Cover change on RCG - RDG relays

RCG and RDG series relays are equipped by a new cover.

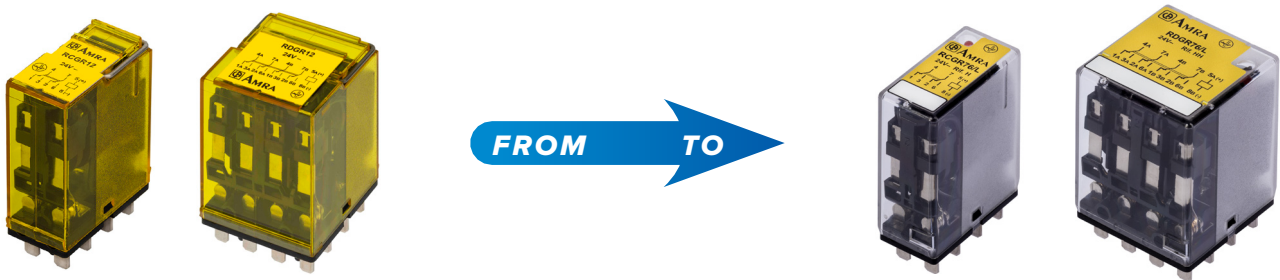
- Product mechanical strength is implemented;
- New indelible marking directly on the cover; it replaces marking by metal plate;
- An area is available for customer markings;
- A matte finishing is implemented. Contacts area will remain transparent and visible;
- Notches to hold retaining clips (optional mounting);
- Extraction handle is suppressed;
- The plastic material is unchanged.
